**Re: Union Gas Limited (“Union”)  
Panhandle 2014 Replacement Project  
Board File # EB-2013-0420**

## **REQUEST TO VARY**

**Project Name:** 2014 Panhandle Replacement Project

**OEB File Number:** EB-2013-0420

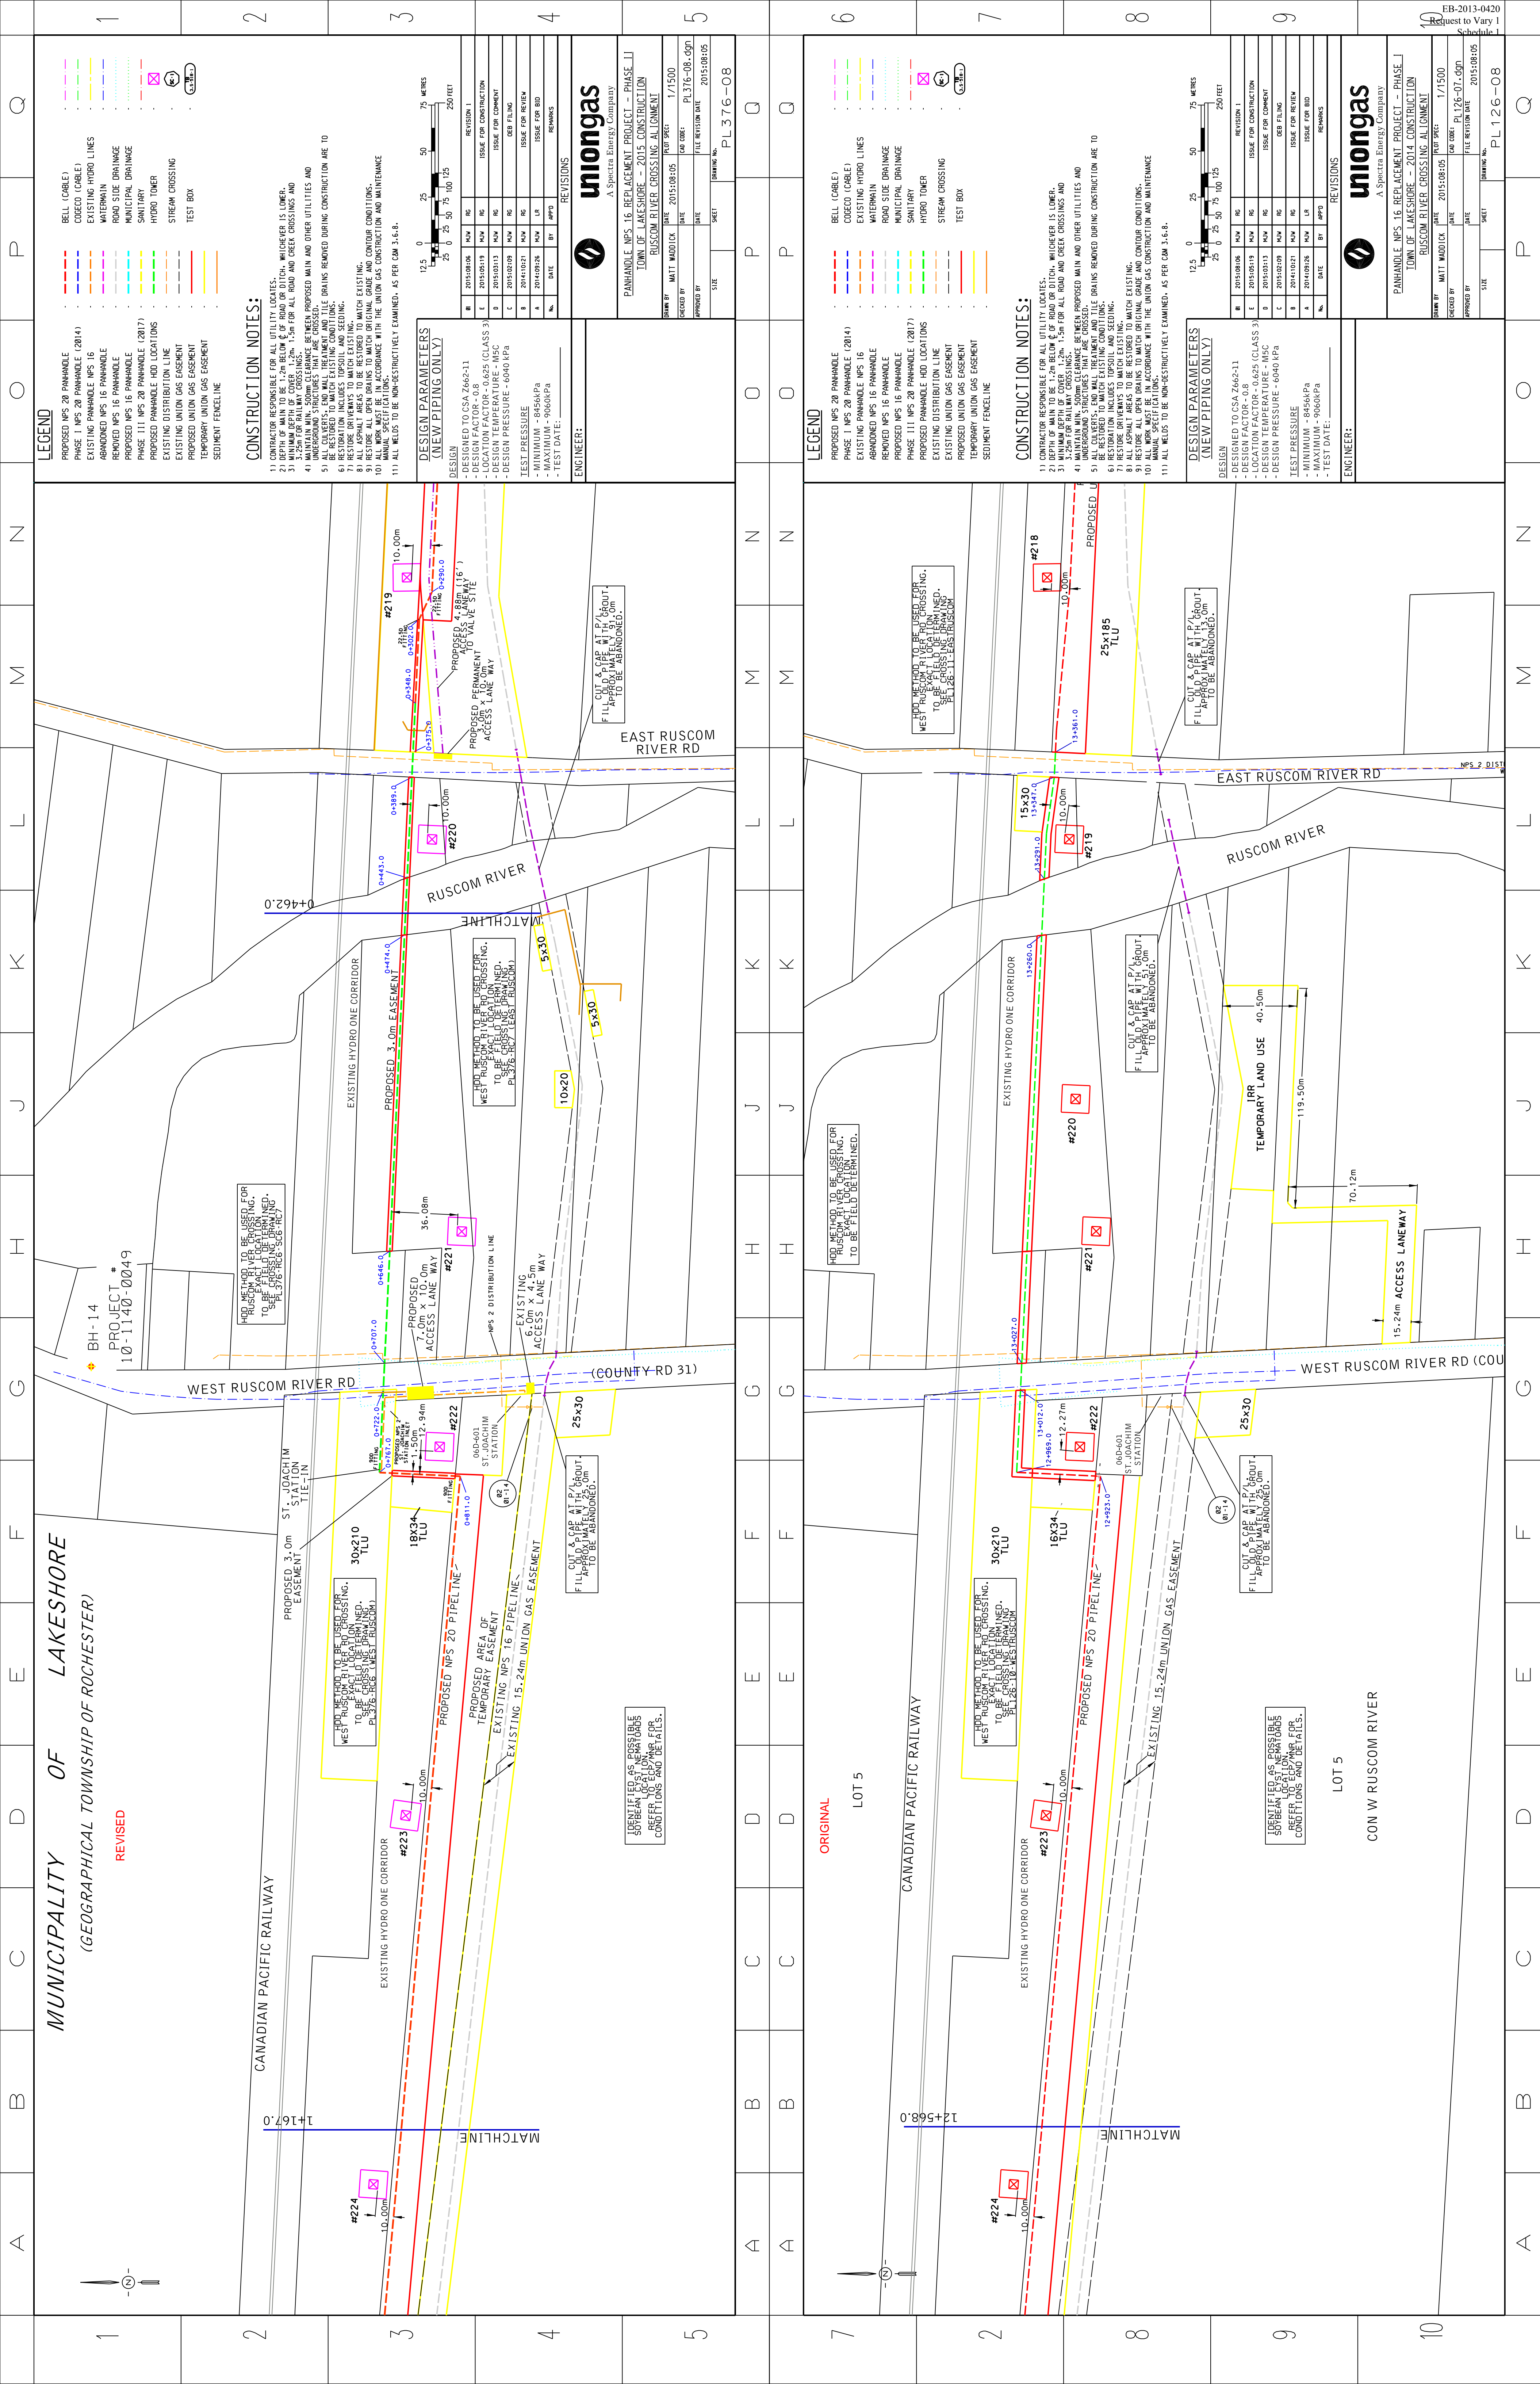
There are a number of changes proposed between West Ruscom River Road and East Ruscom River Road.

Union is now proposing to use the existing easement east of West Ruscom River Road to remove the existing NPS 16 pipeline. This has resulted in a reduction in the amount of temporary lands required. Union now only requires three new small blocks of temporary land to complete the removal of the pipe on the west side of the Ruscom River.

Between the Ruscom River and East Ruscom Road, Union is now proposing to abandon this short section of pipeline in place. Disturbance to the site will be minimized if the pipeline is abandoned in place from east of East Ruscom Road to the west side of the Ruscom River.

A map showing the original proposed temporary lands, and the section of pipe that is to be abandoned in place on the east side of the Ruscom River is attached at Schedule 1.
